**Addendum No.1  
Request for Bids 2026-07  
Greater Columbus Convention Center  
South Entrance Improvements**

Information Contained within this Addendum No.1 modifies the September 24, 2026 Project Manual for the Greater Columbus Convention Center South Entrance Improvements. Receipt of this Addendum No.1 must be indicated on the Form of Proposal submitted by each bidder.

The attached drawings and specifications providing for air curtain and power requirements are hereby incorporated into the Project Manual and made part of the Request for Bids.

**2 FIRST FLOOR NEW WORK PLAN**  
SCALE: 3/16" = 1'-0"

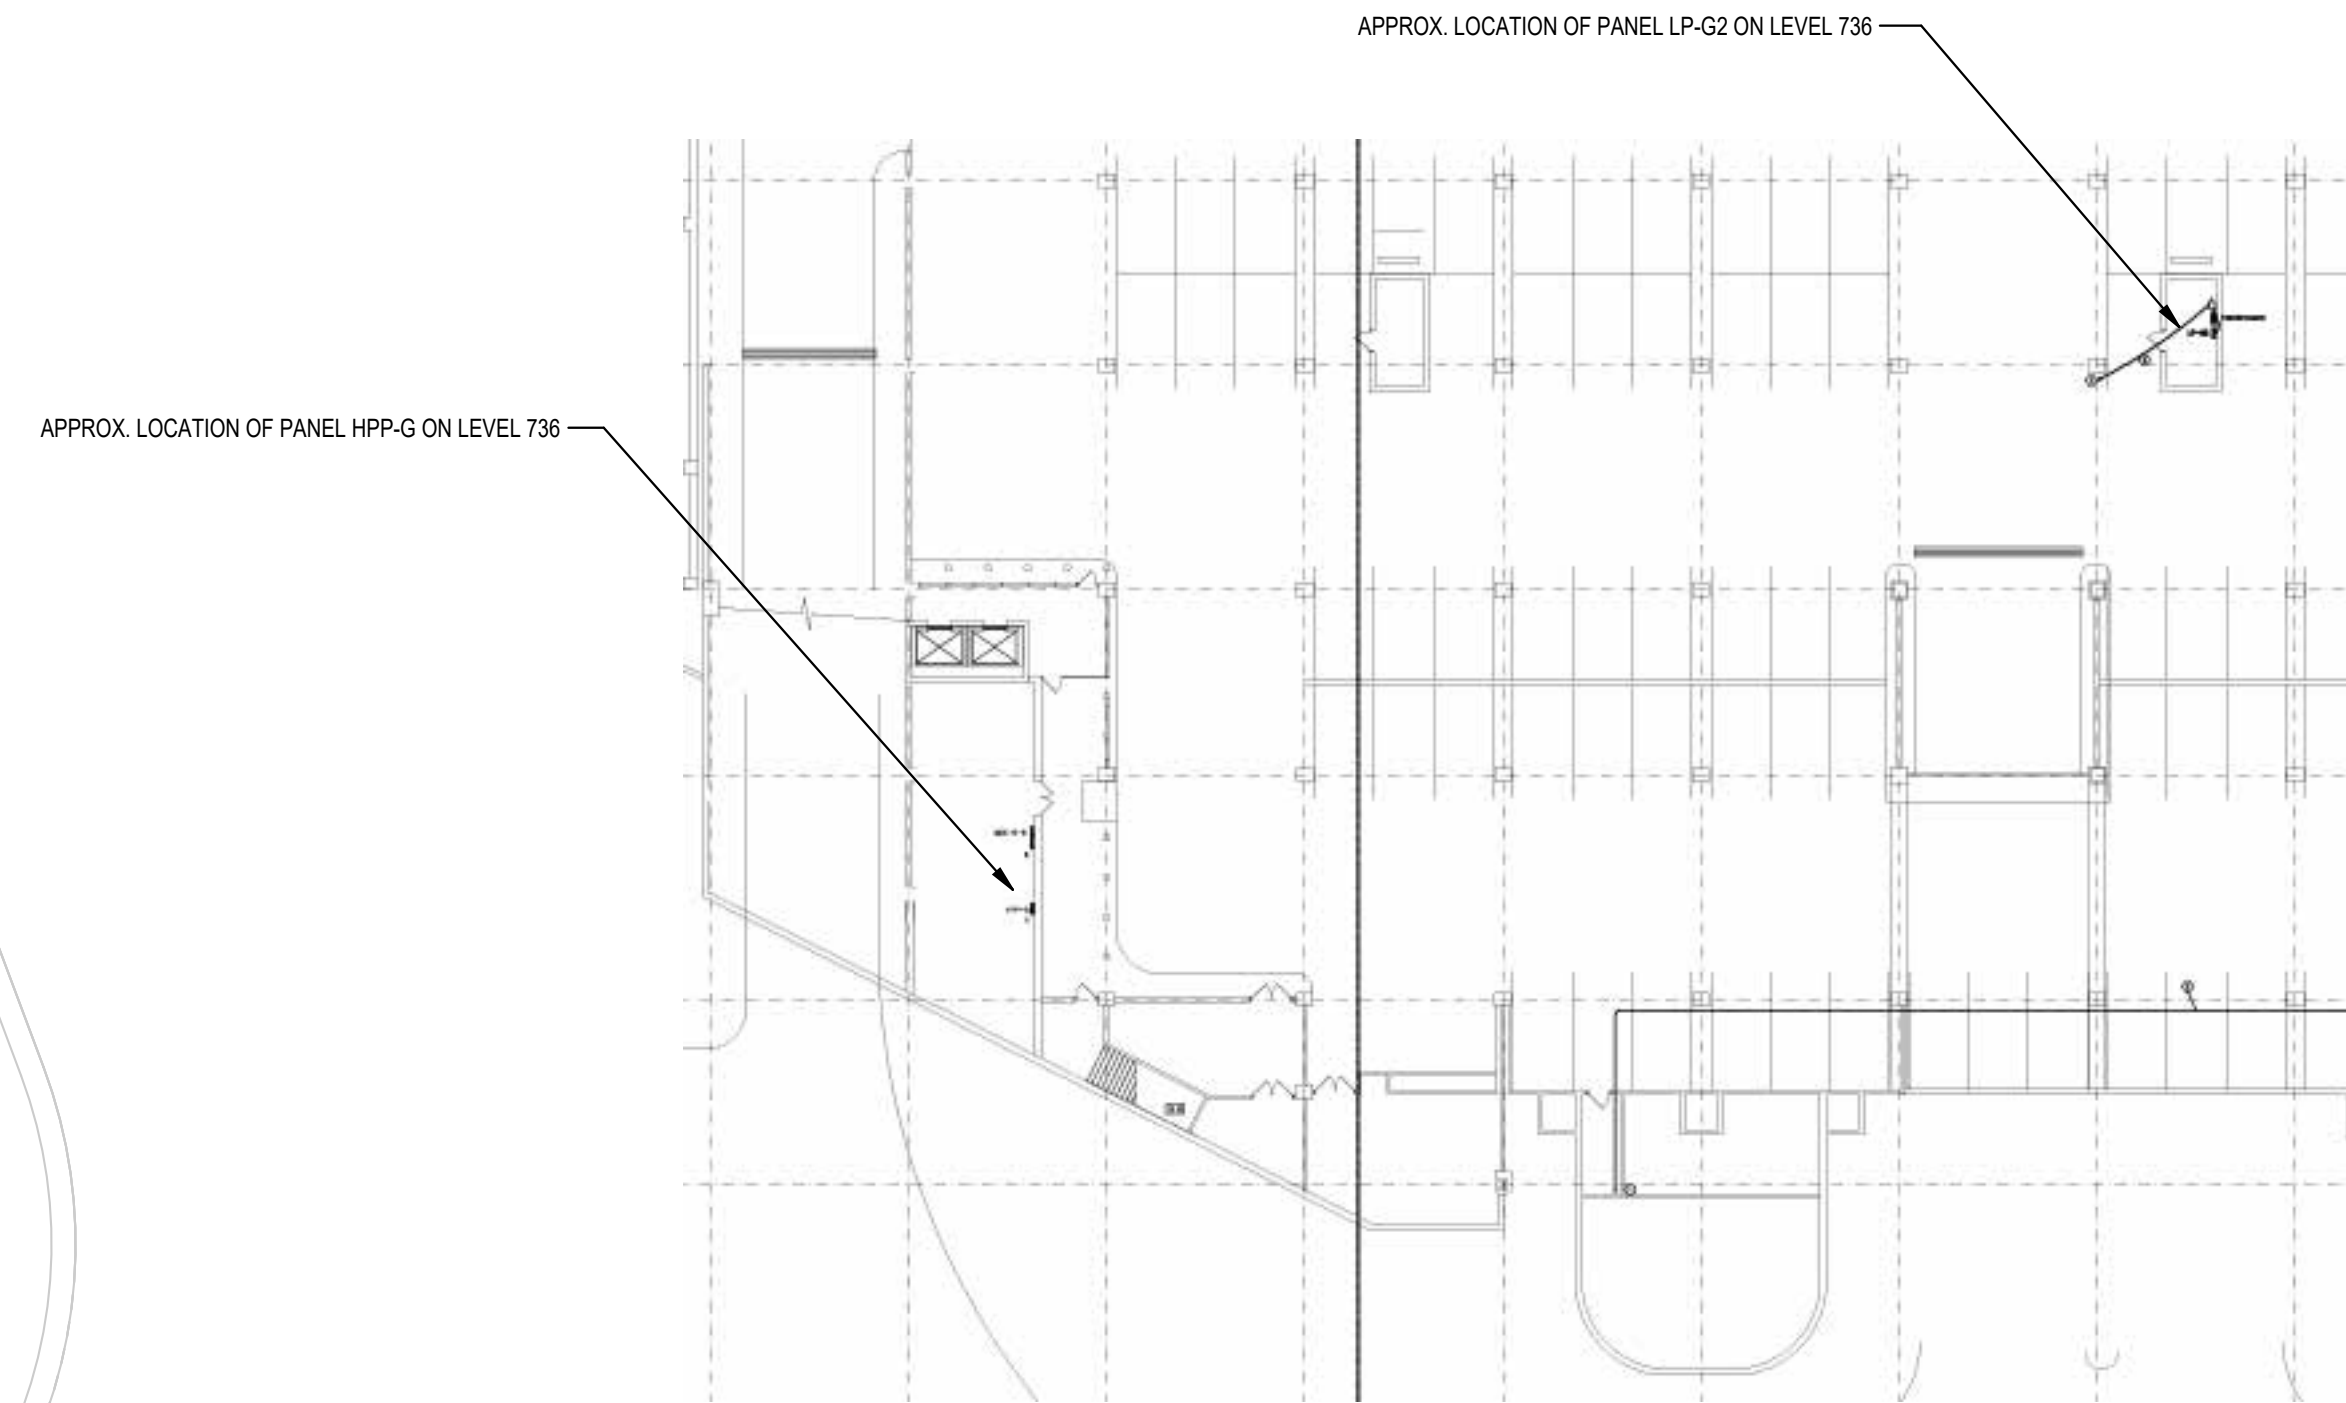
1. NEW AC CURTAIN, PROVIDE 480V, 3PH, 15A CIRCUIT FROM PANEL HPP-G. EC TO FIELD VERIFY AND CONFIRM THAT THERE IS ENOUGH SPACE PRIOR TO START OF WORK. EC SHALL PROVIDE A 30 DAY PEAK DEMAND OF PANEL HPP-G IN ACCORDANCE WITH EXCEPTION UNDER NEC 220.87. TO FEED THE NEW AIR CURTAIN, FIELD COORDINATE ROUTING OF NEW BRANCH CIRCUIT. CONDUIT SHALL NOT BE EXPOSED IN PUBLIC AREAS.
2. PROVIDE 120V, 20A CIRCUIT FOR AUTOMATIC SLIDING DOOR FROM PANEL LP-G2. EC TO FIELD VERIFY AND CONFIRM IF THERE IS SPARE/SPACE PRIOR TO START OF WORK.
3. NEW CARD READER, PROVIDE NECESSARY CONDUIT AND ACCESSORIES FOR A FULLY FUNCTIONAL SYSTEM. COORDINATE ALL WORK WITH LOW VOLTAGE CONTRACTOR.
